Access Compliance Report Public Rights-of-Way (Curb Ramps)

Main Street: WEATHERBY_RD Cross Street: ORANGEWOOD_AVE Location: NE

ADA ID: RPRK211217121228 Ramp Type: Type 1 - Perpendicular Diagonal Initial Pass/Fail: Pass Overall Compliance: No Severity Score: 4

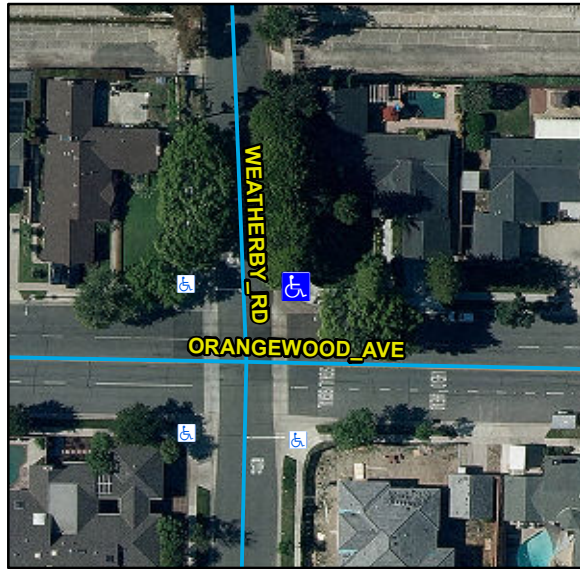
Compliance	Description	Data	Compliance	Description	Data
N/A	Ramp Length (in)	72	N/A	Flare Type LT	
Yes	Ramp Width (in)	48			Sloped
Yes	Ramp Run Slope (%)	7.3	N/A	Flare Slope LT (%)	5.5
Yes	Ramp Cross Slope (%)	0.3	N/A	Flare Traversable LT	No
N/A	Landing Present	Yes	N/A	Flare Type RT	
N/A	Landing Length (in)	40			Sloped
Yes	Landing Width (in)	48	N/A	Flare Slope RT (%)	11
Yes	Landing Run Slope (%)	1.5	N/A	Flare Traversable RT	No
Yes	Landing Cross Slope (%)	1.6	Yes	DWS Provided	Yes
N/A	Landing Movement Obstructed?	Yes	Yes	DWS Contrast	Yes
	Landing Movement Type	Curb	Yes	DWS Length (in)	36
N/A	Landing Shared	No	Yes	DWS Full Width	Yes
N/A	Clear Space	Yes	Yes	DWS Offset Left (in)	1
N/A	Clear Space To Crosswalk (in)	48	Yes	DWS Offset Right (in)	N/A
N/A	Marked Crosswalk 1	No	N/A	Marked Crosswalk 2	No
	Crossing 1 Direction	W		Crossing 2 Direction	S
	Marked Crosswalk 1 Width (in)	N/A		Marked Crosswalk 2 Width (in)	N/A

Remove & Replace Landing.

R304.2.1, STD 1115
